TENNESSEE VALLEY AUTHORITY

In the Matter of the Application of)	Docket Nos. 50-327
Tennessee Valley Authority)	50-328

Enclosed is our response to the Reactor Systems Branch question on Net Positive Suction Head (NPSH) calculations for the ECCS pumps transmitted by your letter to H. G. Parris dated August 23, 1979. This response will be incorporated in Amendment 62 of the Sequoyah Nuclear Plant Final Safety Analysis Report as question 6.63.

6.63 Reactor Systems Branch (212.0)

FIGURE 1-SUCTION PIPING FROM ECCS SUMP

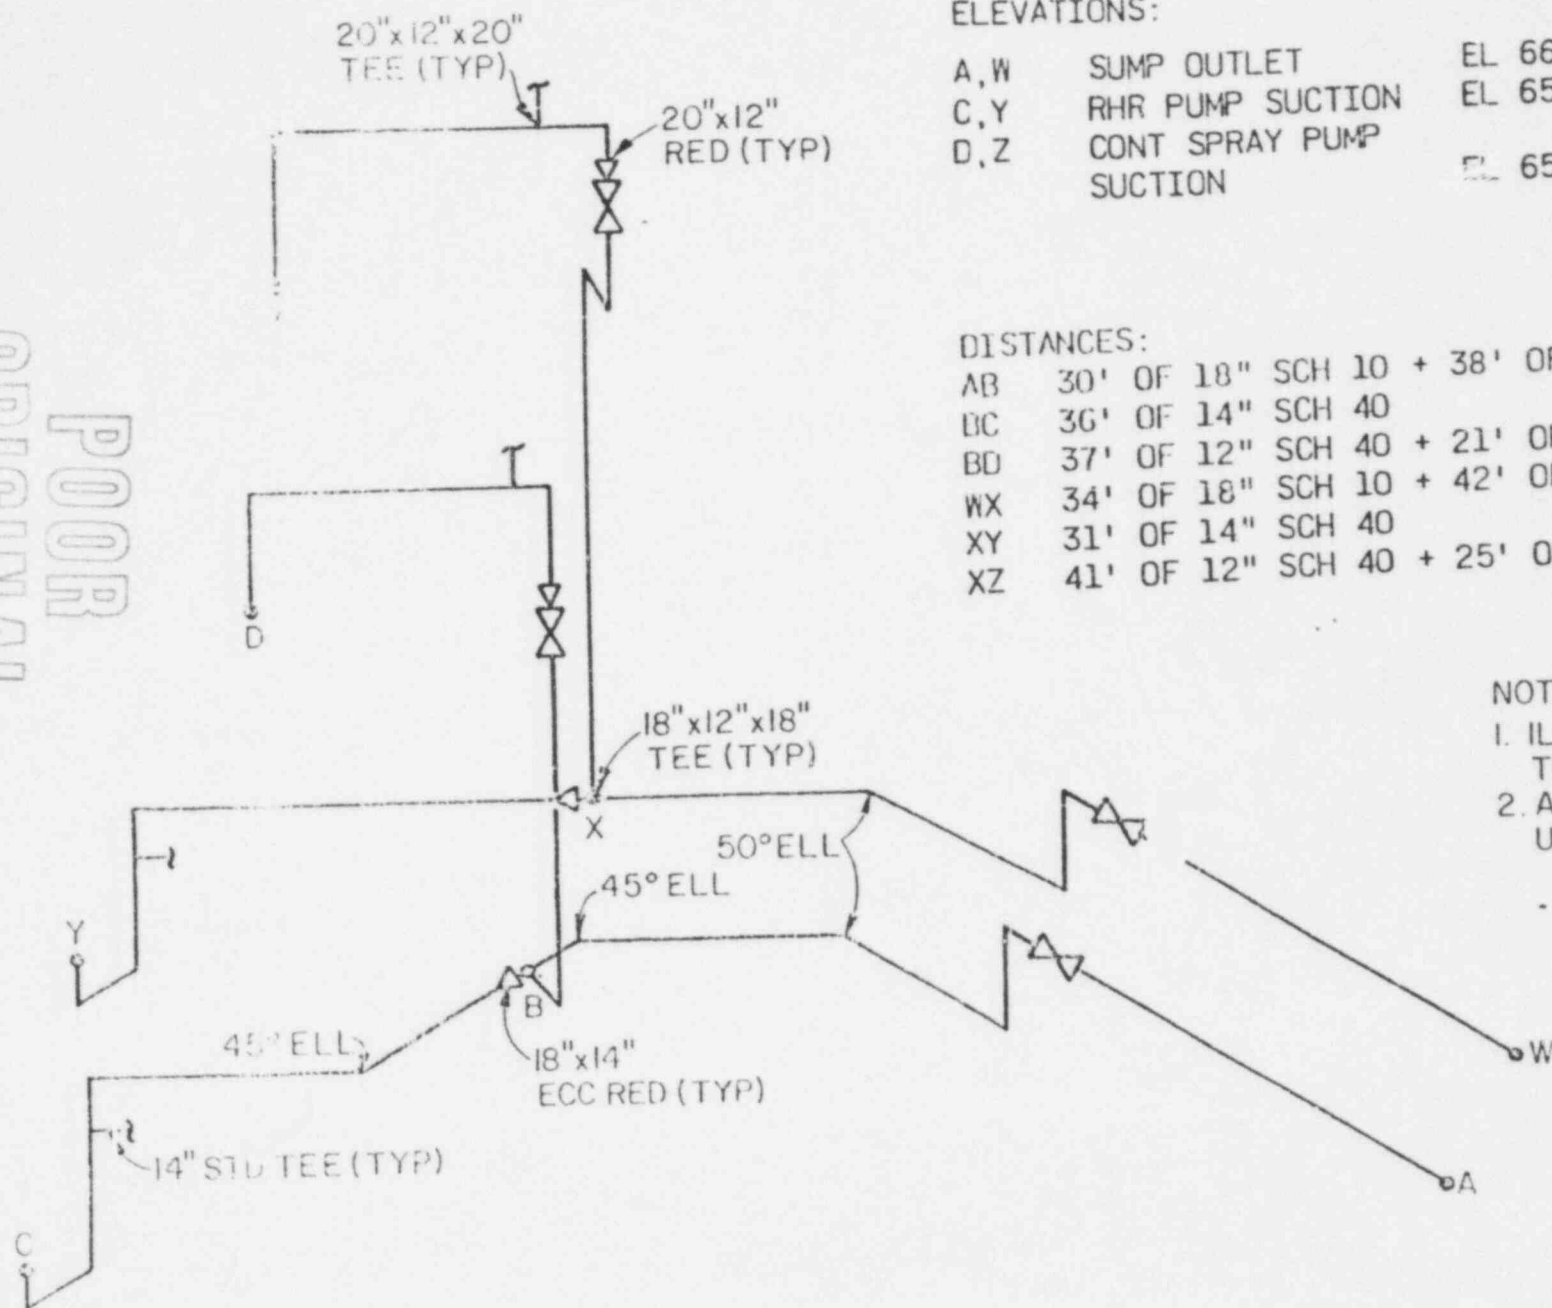
Provide the following information to resolve the staff's concerns whether sufficient NPSH is available to RHR pumps during a worst-case flow condition:

- (a) Show that the kinetic head loss term ($V^2/2g$) has been appropriately factored into the NPSH analysis by identifying that it was included in the pump manufacturer's specification of required flow, or by including it in the calculations provided.
- (b) Provide preoperational test results which demonstrate that for a worst-case flow condition flow through the as-built RHR pumps will not exceed that assumed in the analysis (4500 gallons per minute). Include discussion(s)/data interpretation to verify the worst-case flow condition (i.e., address the RHR auxiliary containment spray) from the sump and to confirm that sufficient NPSH is available to the ECCS pumps.

The friction losses for the common piping are greatest in the longer length, W to X in figure 1. Losses in this section computed using reference 2 are:

The friction losses to the RHR pump are greatest in the longest length, B to C in Figure 1. Losses in this section computed using reference 2 are:

The friction losses to the CSS pumps are greatest in the longest length X to Z in Figure 1. Losses in this section computed using reference 2 are:
